CWSP SYSTEM HARDENING FIELD SCOPING DOCUMENT

PM: ██████████	Project Name: SH - BUCKS CREEK 1101 CB	
Notification: 120047659	Region: Northern	City: Rock Creek
Project Manager: ██████████	Division: North Valley	County: Plumas

- A) **Project Area** – Google Earth Image with Circuit and HFTD Tier 2 &3 Overlay

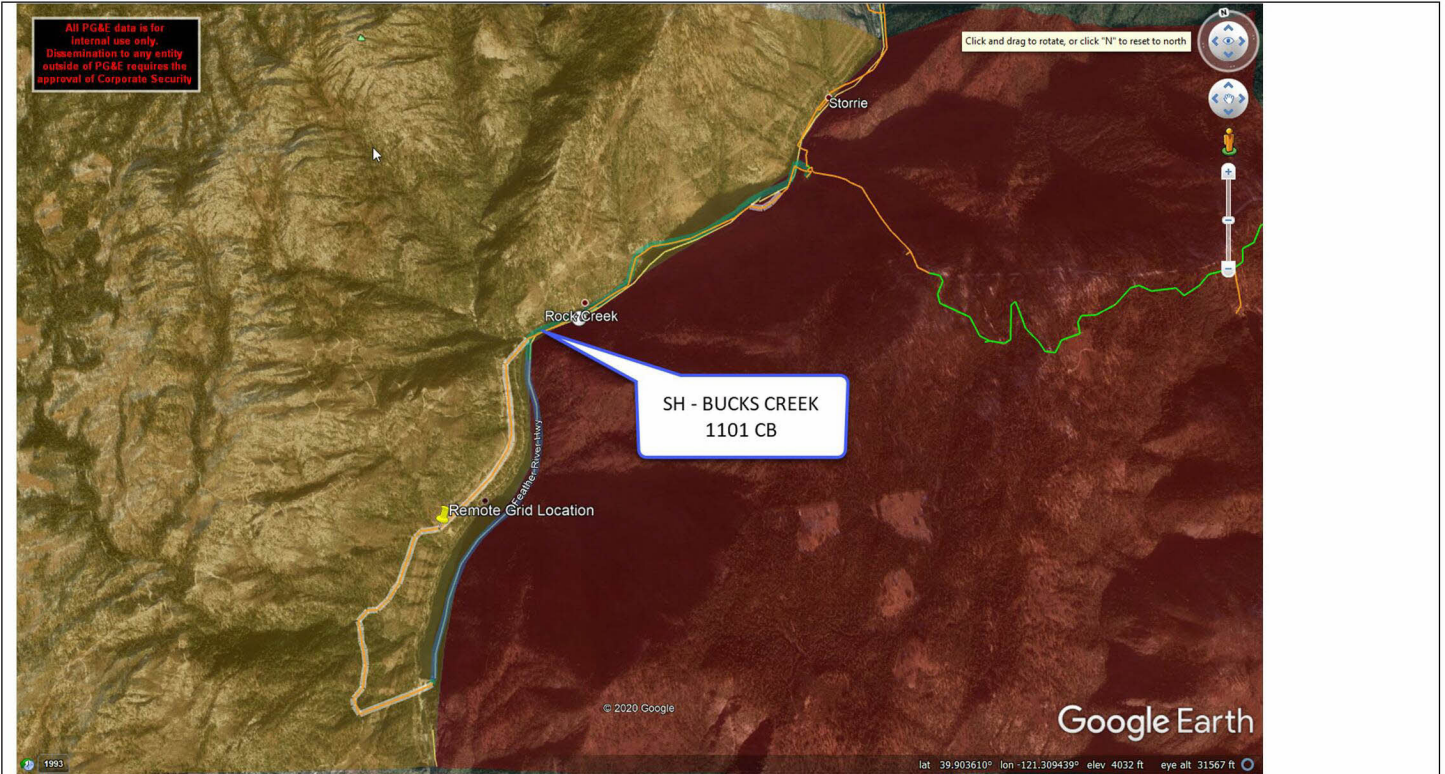
- This project crosses Highway 70 near the Bucks Creek Powerhouse and then parallels the highway for a roughly 2-mile stretch, and then runs along Storrie Rd. paralleling the Feather River on the canyon opposite side of Highway 70. Highway 70 is a main thoroughfare for ingress/egress for emergency responders and to the few residents who live in that direct area; it is also a major route for commerce both by vehicle and railroad.
- If Highway 70 was closed in this area it would make ingress and egress difficult if not impossible for responders and citizens; and, economically be a substantial hit to commerce. There are no alternative routes within the Feather River Canyon.

B) Fire History – WIFire Map at <https://firemap.sdsc.edu/> to produce the fire history image.

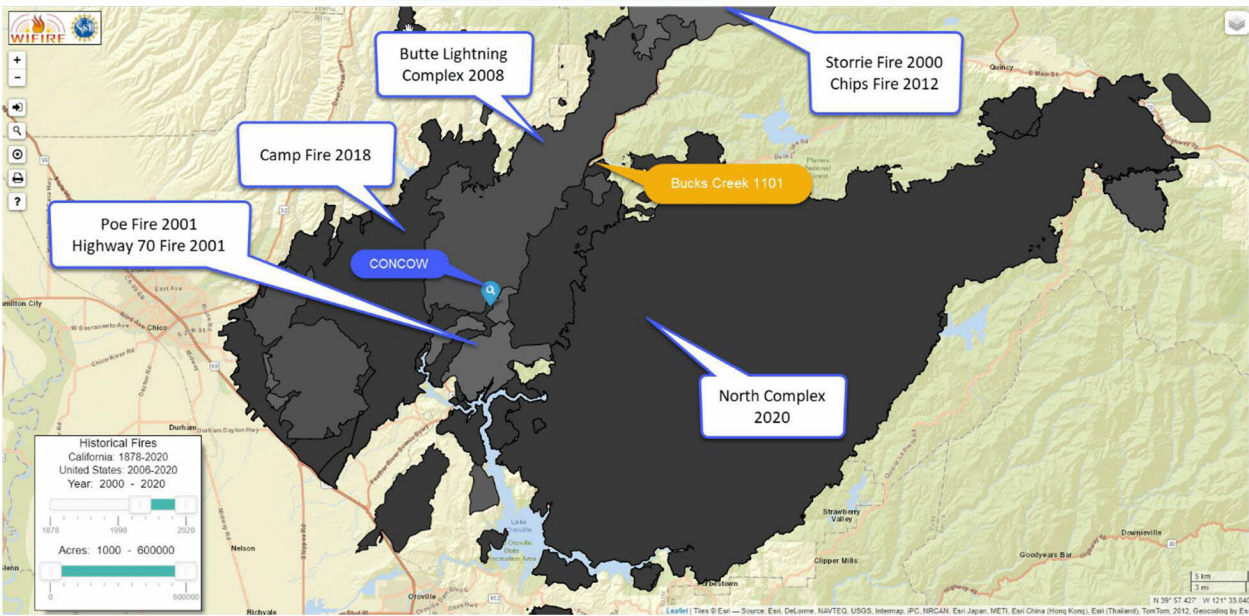
- This area has significant fire history directly impacting the project area. A 20 year look back at area fire history includes, the 56,000 acre Storrie fire (2000), 8,000 acre Poe fire (2001), 1700 acre Highway 70 fire (2001), 50,000 acre Butte Lightning Complex (2008), Canyon Complex (2008), 30,000 acre Chips Fire (2012), 154,000 acre Camp fire (2018) and the 320,000 acre North Complex 2020 all burned within the Feather River Canyon.

- Not all the fires were directly in the project footprint area; however, they show that this area is prone to significant, large fire history due in large part to steep, rugged, inaccessible terrain and periods of strong wind.
